25 January 2021

EN020022: AQUIND INTERCONNECTOR The Examining Authorities further written Questions for National Grid Electricity System Operator, Reference EIA 2.6.1

Figure 1 : The Southern Transmission System¹

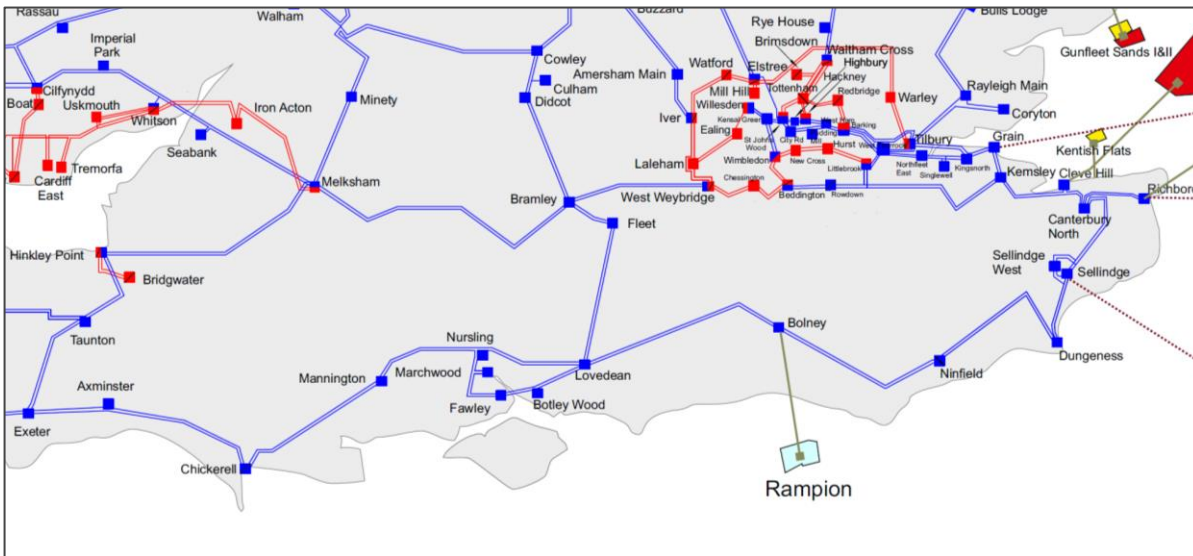
In the case of AQUIND Interconnector, the CION did not progress with 7 existing substations. Bolney , Botley Wood, Fawley, Marchwood, Nursling, Mannington and Fleet these substations were not taken forward to the next stage of the CION due to the following reasons.

1. Options to the West of Lovedean required all or nearly all the same network reinforcements as a connection at Lovedean plus additional reinforcements to either get the power to Lovedean or reinforcements to the west to Exeter substation and as far northwards as Minety.
2. Options to the East of Lovedean again required the same reinforcements as a connection to Lovedean plus additional reinforcements to either get the power to Lovedean, or further on the east coast.
3. Options to the North of Lovedean would require more infrastructure than for the coastal connections. It is assumed that a longer inland cable route would have a greater environmental impact. In this case the cable length was almost 3 times the length of the connection to Lovedean and the shortest route suggested would have been passing through the National Park.

With the above considerations in mind these 7 substations were not taken forward for further assessment. This is because these sites would likely have resulted in more overall reinforcements, which would therefore lead to more environmental impact, and increased costs to the GB consumer. The extent of these additional works will vary from site to site but may involve new overhead lines or cables, additional operational equipment and multiple substation extensions in addition to the works identified for a connection at Lovedean.
